Customer Advice Note

CAN #179

Galaxy Flex

Jumper Settings

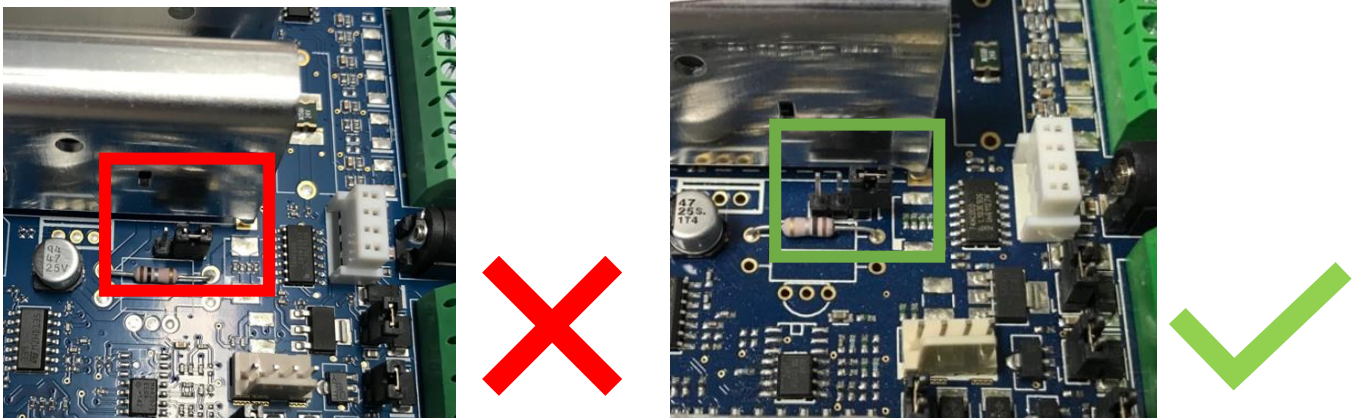
A number of Galaxy Flex Systems have shipped with the PSU jumper **PL6** closed on the Control Unit PCB.

Locate the **PL6** Jumper on the PCB. This Jumper should be in an open position.

PL6 is used to limit AUX current for variant of PSU 2A / 1A

- Jumper open = 1.8 A
- Jumper closed = 0.9 A

Please remove jumper and retain.

This Jumper must be **Open** on 'L' models as they have a 2A PSU. All 'M' and 'S' models the Jumper is **Closed** as they have a 1A PSU.
